LR-N00-0405  
LCR H00-05

**REQUEST FOR LICENSE AMENDMENT  
INCREASED LICENSED POWER LEVEL  
HOPE CREEK GENERATING STATION  
FACILITY OPERATING LICENSE NO. NPF-57  
DOCKET NO. 50-354**

**HOPE CREEK GENERATING STATION  
FACILITY OPERATING LICENSE NO. NPF-57  
DOCKET NO. 50-354  
CHANGE TO TECHNICAL SPECIFICATIONS  
INCREASED LICENSED POWER LEVEL**

Figure 3.4.6.1-2

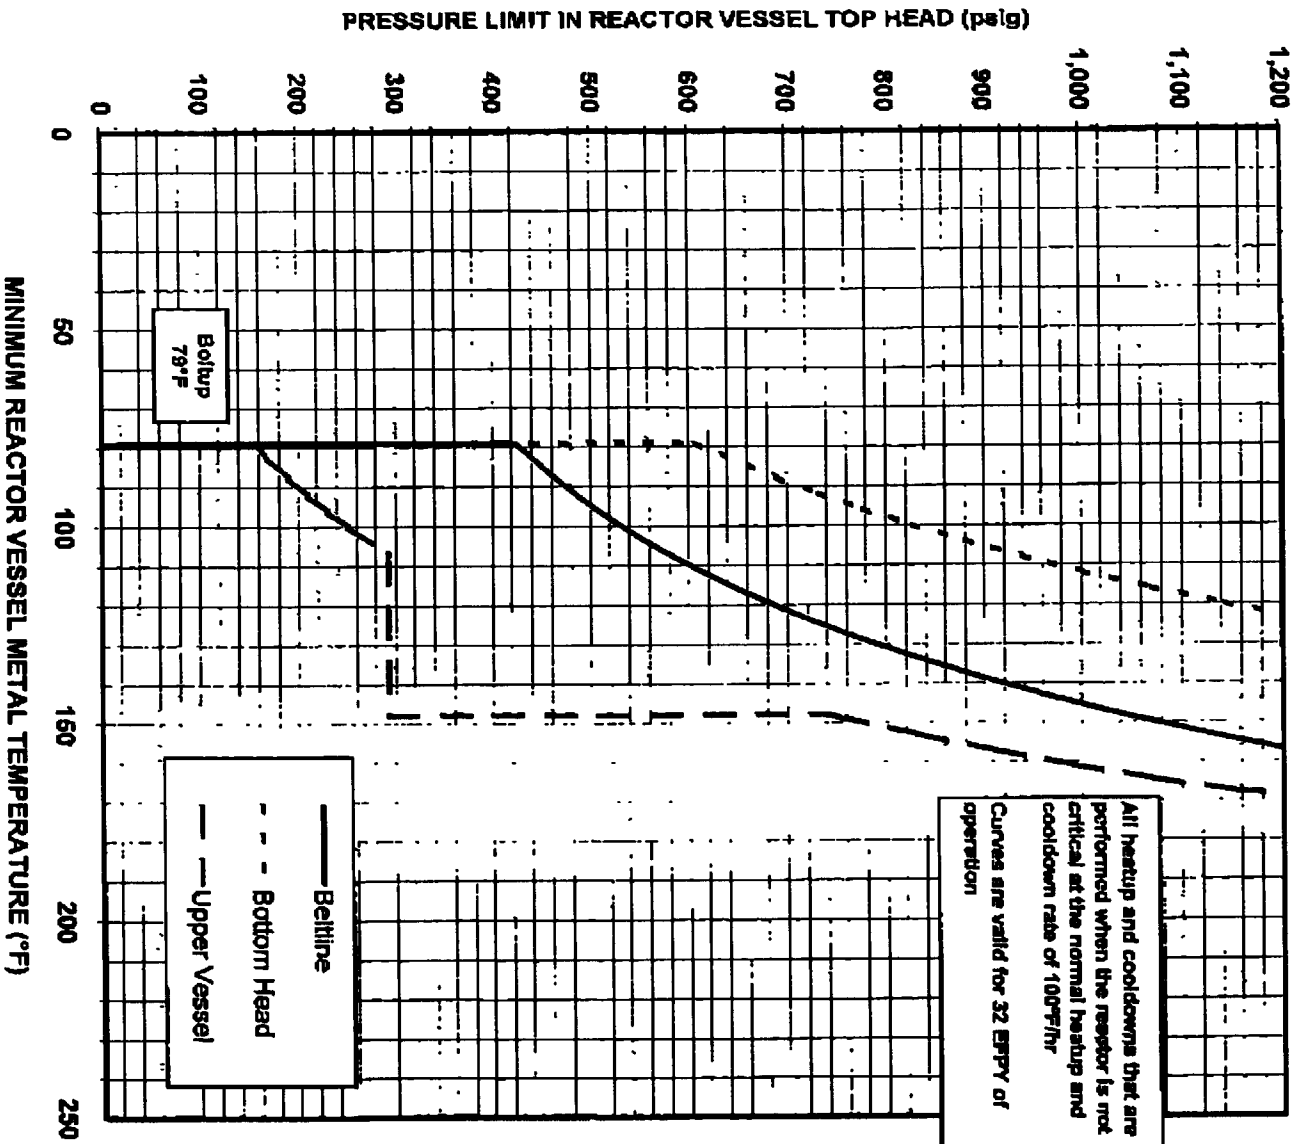
1. Technical Specification Figures 3.4.6.1-1, 3.4.6.1-2 and 3.4.6.1-3, pressure-temperature limit curves for hydrostatic testing, non-nuclear heatup and cooldown, and critical operation, and their associated Bases are revised to support the increase in core power based on uprated fluence projections.
2. Surveillance Requirement 4.4.6.1.4 is being revised to be made consistent with the limit on reactor vessel flange and head flange metal temperature in TS 3.4.6.1.d.

FIGURE B 3/4 4.6-1 FAST NEUTRON FLUENCE ( $>1$  MeV)  
 AT 1/4 T AS A FUNCTION OF SERVICE LIFE

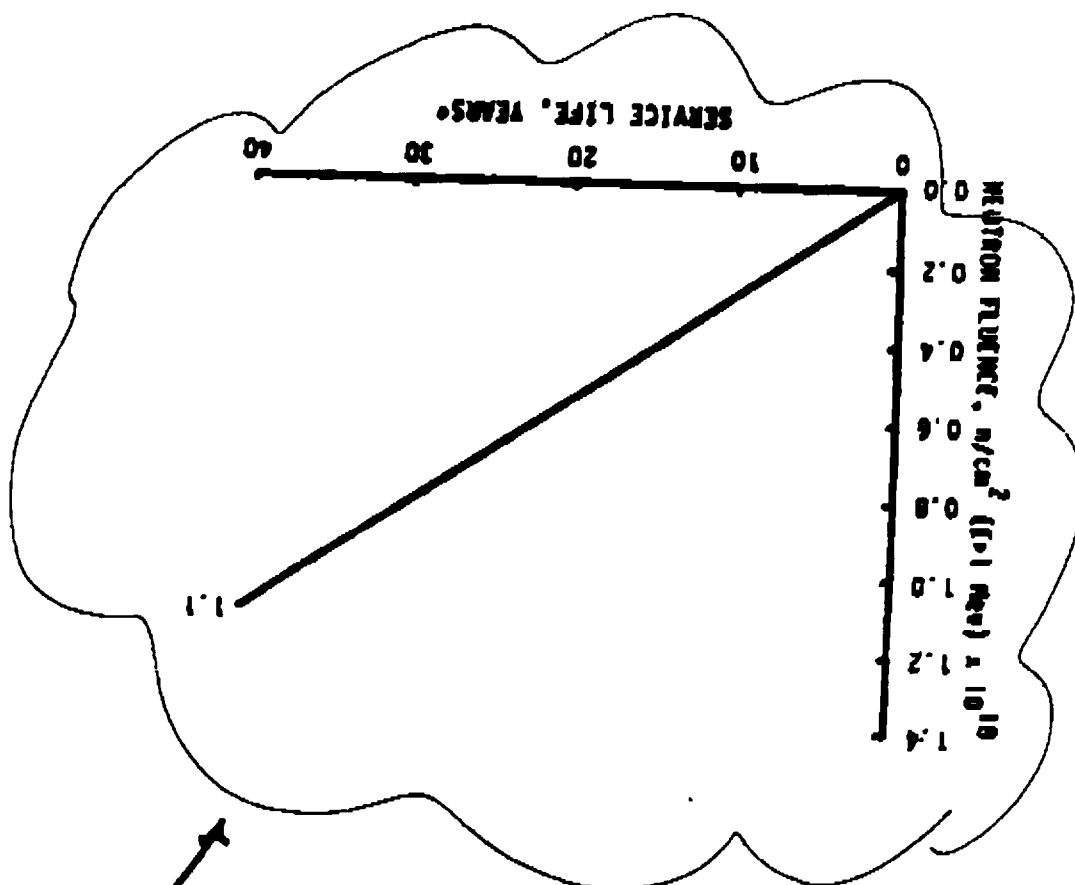
1. In TS Bases 3/4.4.6, references to ASME Boiler and Pressure Vessel Code, Section III, Appendix G are being changed to Section XI, Appendix G which is the correct reference for requirements related to reactor vessel pressure-temperature limits.
2. The TS Index is being revised to correctly show the locations for Figures 3.4.6.1-1, 3.4.6.1-2 and 3.4.6.1-3.
